EISENHOWER MEMORIAL

SECTION 106 MEETING DECEMBER 9, 2014

MOA STIPULATION 10: DESIGN RESPONSE TO NCPC PRELIMINARY REVIEW

MEMORIAL CORE PLAN

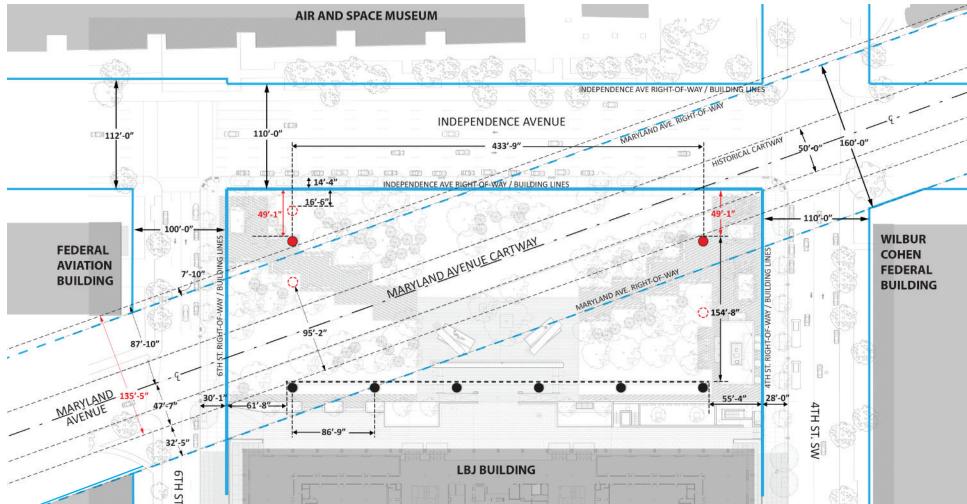
SUMMARY OF REVISIONS TO MEMORIAL CORE

- 1. Memorial core elements have been reconfigured to be more open to the approach paths.
- 2. Massing of Memorial core elements has been revised and a lintel has been added.
- 3. The Memorial elements have been revised to include free-standing bronze statues in front of bas reliefs.
- 4. The inscription on the Memorial Overlook wall has been replaced with the text: Dwight D. Eisenhower
- 5. Inscriptions of the selected speeches were relocated to the rear facade of the memorial elements.
- 6. Young Eisenhower sculpture is seated on the Overlook wall.

VIEW ALONG MARYLAND AVENUE TOWARDS CAPITOL

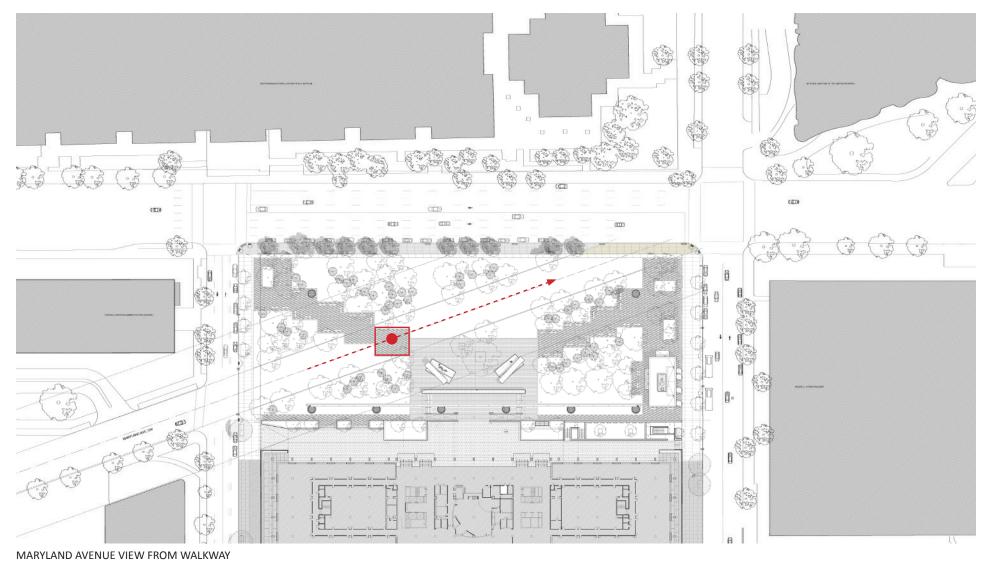
VIEW ALONG MARYLAND AVENUE TOWARDS CAPITOL - The design revisions widen the Maryland Avenue viewshed from 95' to 135' wide, creating a proportionally *horizontal* frame to the Capitol building.

APPROVED PRELIMINARY DESIGN OCTOBER 2014 - TREE SPECIES PLAN

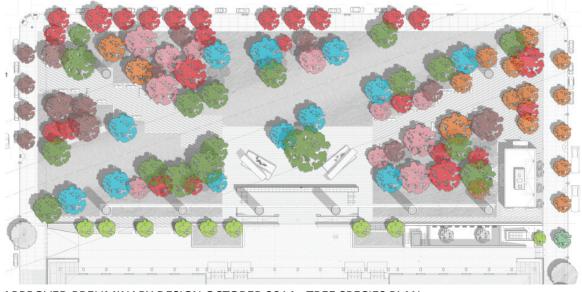
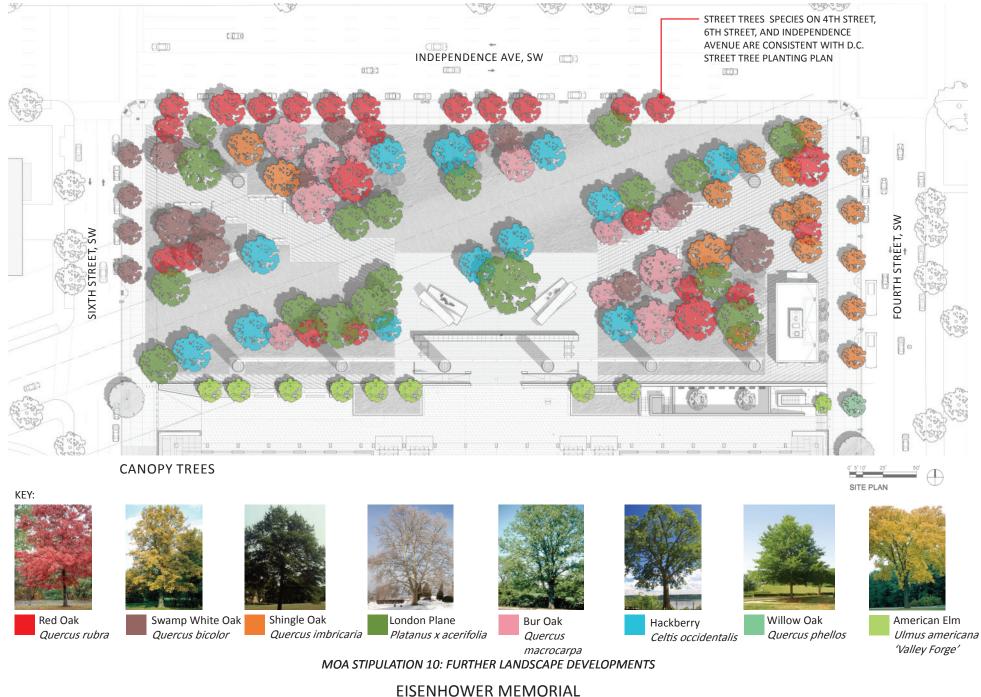
SHADE CANOPY TREES COMPARISON

SUMMARY OF DESIGN RESPONSES FROM DECEMBER 2011 TO APPROVED PRELIMINARY DESIGN OCTOBER 2014

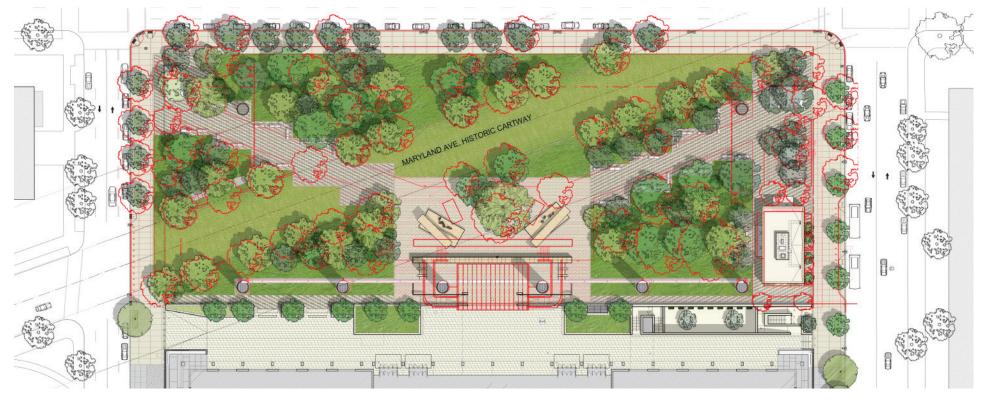
- 1. The east and west tapestries have been removed and replaced with a single columns.
- 2. Two northern columns are fully within planes of the adjacent building facades.
- 3. The revised design widens the Maryland Avenue viewshed from 95'-2" to 135'-5".
- 4. LBJ Perimeter security has been revised to reduce the need for bollards.

- 1. Memorial core elements have been reconfigured in plan to be more open to the approach paths.
- 2. Massing of Memorial core elements has been revised and a lintel has been added.
- 3. The Memorial elements were revised to include free-standing bronze statues in front of bas reliefs.
- 4. The inscription on the Memorial Overlook wall has been revised to: Dwight D. Eisenhower
- 5. Inscriptions of the selected speeches were relocated to the rear facade of the memorial elements.

- 1. Street trees have increased and species revised to comply with D.C. tree planting plan.
- 2. Tree selections incorporate 3 species that were part of the original LBJ plaza plant palette.
- 3. Proposed bus turnout on 4th street has been removed.
- 4. Diagonal walkways have been reconfigured to incorporate smaller gathering spaces.
- 5. 87 additional trees have been added to the site plan, including understory trees.

- 1. The separate storage building has been removed.
- 2. Visitor seating areas have been increased.
- 3. An entrance vestibule has been added to the North facade.
- 4. Canopies have been revised.

- 1. The Memorial Overlook canopy has been removed.
- 2. The Overlook stair and ramp approach to the LBJ building have been revised.
- 3. Planter sizes have increased.
- 4. The central gathering area has been reshaped and includes bench seating.
- 5. Terraced seating on the west end has been reconfigured.
